UNITED STATES PATENT AND TRADEMARK OFFICE

APPLICATION NO.	FILING DATE	FIRST NAMED INVENTOR	ATTORNEY DOCKET NO.	CONFIRMATION NO.
10/521,431	01/14/2005	Kenji Sato	XA-10243	1528
181 7590 10/31/2007 MILES & STOCKBRIDGE PC 1751 PINNACLE DRIVE SUITE 500 MCLEAN, VA 22102-3833				
EXAMINER WATTS, ALAN B				
ART UNIT 4112		PAPER NUMBER		
NOTIFICATION DATE 10/31/2007		DELIVERY MODE ELECTRONIC

Office Action Summary

DETAILED ACTION

Fig. 2

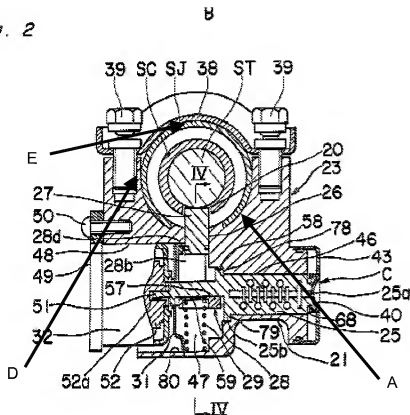
- Steering column (fig 2 below) provided with a steering lock mount portion (SJ, fig 2 below) on its outer circumference and supporting a steering shaft rotatably (ST, fig 2 below)

- Steering lock (bottom portion of fig 2) having a lock key (36, fig 3) for latching said steering shaft (ST, fig 2 below) and a contact portion (A, fig 2 below) that is in contact with a part of said steering lock mount portion (SJ, fig 2 below) of said steering column (fig 2 below)

- Lock bracket (38, fig 2 below) having a contact portion (E, fig 2 below) that is in contact with another part of said steering lock mount portion (SJ, fig 2 below)

- Contact portion (A, fig 2 below) of said steering lock (bottom portion of fig 2) and said contact portion (E, fig 2 below) of said lock bracket (38, fig 2 below) embracing said steering lock mount portion (SJ, fig 2 below) of said steering column (fig 2 below)

- Steering lock mount (SJ, fig 2 below) of said steering column (fig 2 below) abuts at least one of said steering lock (bottom portion of fig 2) and said lock bracket (23 and 38, fig 2 below) with an abutting surface having a non-circular cross section (D, fig 2 below)

- Steering lock mount portion (SJ, fig 2 above) abuts said steering lock (bottom portion of fig 2) with a circular cross section (A, fig 2 above)
